PLANNING COMMISSION MEETING

STAFF REPORT TO THE AMITY PLANNING COMMISSION

MEETING: April 22, 2024
TO: Amity Planning Commission
FROM: Holly Byram, City Planner, Mid-Willamette Valley Council of Governments (MWVCOG)
RE: **Public hearing for land use files #2403-01 SDR & 2404-01 VAR “Pickleball Courts”**
EXHIBITS: A – Combined department & agency comments
B – Application materials submitted

- C. **TAX LOT:** R5429AB 02700
- D. **PROPOSAL:** The Amity School District proposes to develop six paved pickleball courts on the west side of the existing grass play field. The district also proposes a concurrent variance to the city’s adopted fence standards in terms of both height and location. The fence along Trade Street/99W is proposed be 10 ft tall, along Nursery and Getchell 6 ft tall, and facing east to the field 4 ft tall. No other site improvements are proposed. The rest of the block would remain undeveloped grass play field.

N. PROPOSED SITE PLAN (Source: Application materials)

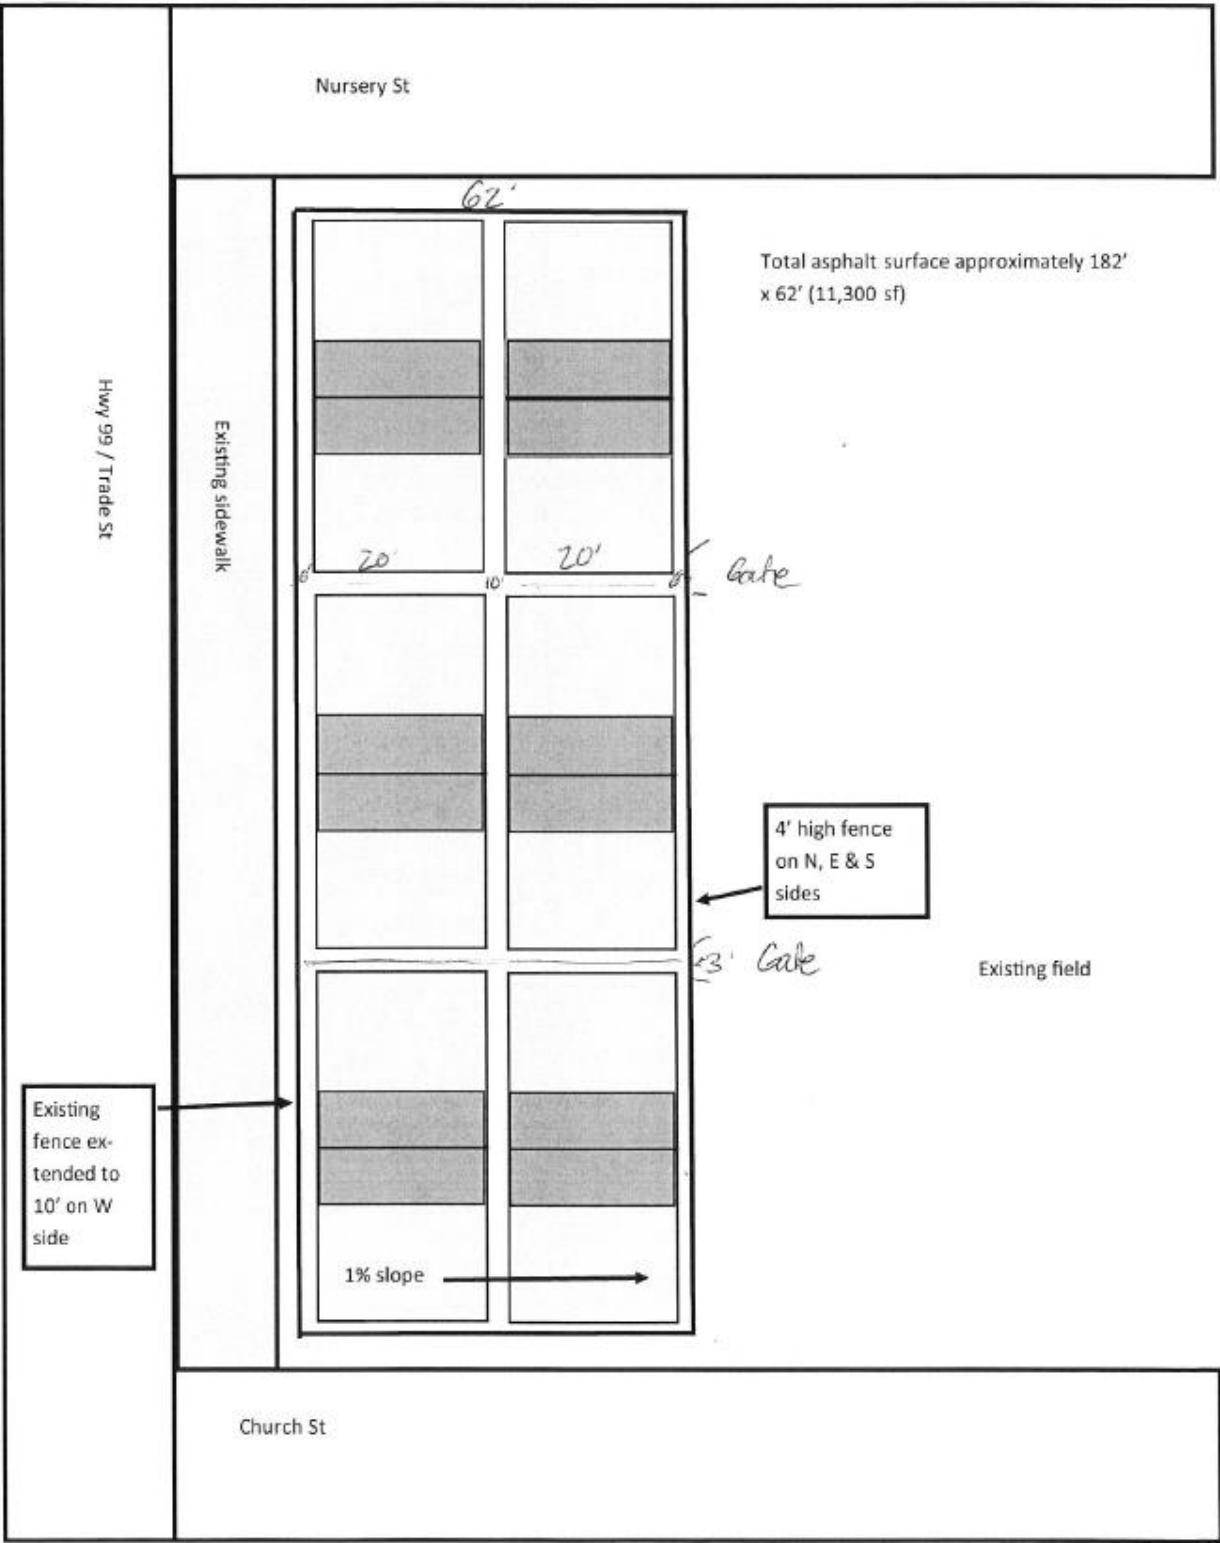
- a. Trade Street / 99W. ODOT jurisdiction. Arterial minimum total width 88 feet, 44 feet from centerline. Currently approximately 70 feet. Approximately 9 feet of frontage required.
- b. Nursery Street / OR-153. ODOT jurisdiction. Arterial minimum total width 88 feet, 44 feet from centerline. Currently approximately 60 feet. Approximately 14 feet of frontage required.
- c. Getchell Street. City jurisdiction. Local minimum total width 50 feet, 25 feet from centerline. Currently approximately 47 feet. Approximately 1.5 feet of frontage required.
- d. Church Street. City jurisdiction. Local minimum total width 50 feet, 25 feet from centerline. Currently approximately 40 feet. Approximately 5 feet of frontage required.

FINDINGS: Requirements for off-street parking are detailed in ADC 2.203 Off-Street Parking and Loading. The total number of vehicle parking spaces required is based upon the types of land uses, and the size of those uses. ADC 2.203.05 gives ratios for quantity of parking spaces. The undeveloped playfield is an existing use and a historic non-conforming (grandfathered) condition where no off-street parking is provided. The school district proposes to change the programming of the type of recreation provided on the site; by providing pickleball in addition to the existing use by baseball, softball, soccer, football, etc. But no additional square feet of recreational space are proposed. The application states that vehicles park on the streets abutting the field or across the street in the School District Office parking lot(s). No off-street parking is proposed or required to be added. While staff supports this existing non-conforming situation for the vehicle parking, there is currently no bicycle parking available at this recreational facility. ADC 2.203.11 addresses bicycle parking, requiring 1 bicycle space for every 10 vehicle spaces required. While there is no specific category of vehicle parking which fits closely, "recreational services" require 1 space per 200 SF. Using 11,300 SF pickleball courts/200 SF = 57 spaces /10 = 5.7 bicycle spaces.

FINDINGS: Storm drainage standards are provided in ADC 2.204 Storm Drainage. The City Engineers have reviewed the application package, and their comments are attached in Exhibit A. At approximately 11,300 SF, the proposed size of new impervious surface exceeds the 5,000 SF threshold to trigger storm water plans and control facility. In compliance with Section 4 of the adopted Public Works Design Standards, the applicant will need to demonstrate how much additional runoff will be generated and how it will be controlled on site. This standard can be met through the applicant's compliance with the related recommended condition of approval.

FINDINGS: The proposed pickleball courts site plan shows chain link fencing of a couple different heights. The new fencing is proposed to be 10 feet tall along Trade St (west). It is proposed to be 6 feet tall along Nursery and Church Streets (north and south). And it is proposed to be 4 feet tall along the grass field (east). The applicant's site plan shows the 10-foot tall fence directly on the front property line. The applicant has applied for a Major Variance to the fence standards, seeking approval to erect a fence 10 feet in height along the Trade Street frontage which exceeds both the 4-foot front yard fence height limit within the first 10 feet from the front property line, and the 7-foot fence height on other interior yards. For this reason, the applicant has submitted a concurrent Major Variance along with the Site Development Review application.

4. REVISED SITE PLAN: Prior to construction, the applicant shall submit a final site plan which demonstrates compliance with the following conditions of approval.

5. SURVEYED BOUNDARIES: Prior to construction, the applicant shall submit a final site plan demonstrating surveyed accurate property boundaries, right-of-way to be dedicated, and footprint of proposed recreational facilities (courts, fence, ADA pathway, bike racks), drawn to scale with dimensions and setbacks labeled.

6. TRADE STREET RIGHT-OF-WAY DEDICATION: Prior to facility use, the applicant shall dedicate to the Oregon Department of Transportation (ODOT), a street right-of-way equal to 44 feet from centerline, approximately 9 feet of frontage, consistent with the 2015 Amity Transportation System Plan (TSP) Future "Arterial" Street Classification, and the 2021 Public Works Design Standards, Section 5.2.

8. ADA ACCESS: Prior to construction of new facility, applicant shall demonstrate on the revised site plan a paved accessible route for pedestrian access from the public sidewalk to the new recreation facility, in compliance with applicable ADA standards.

9. BICYCLE PARKING: Prior to construction of new facility, applicant shall demonstrate on the revised site plan provision of bicycle parking facilities to accommodate at least six (6) bicycles which is three (3) racks total. Pursuant to the standards in ADC 2.203.11, each bicycle parking space shall be at least 2 feet by 6 feet with a vertical clearance of 6 feet. Structures that require a user-supplied lock shall accommodate both cables and U-shaped locks and shall permit the frame and both wheels to be secured. Standard “inverted-U” or “staple” type bike racks are recommended.
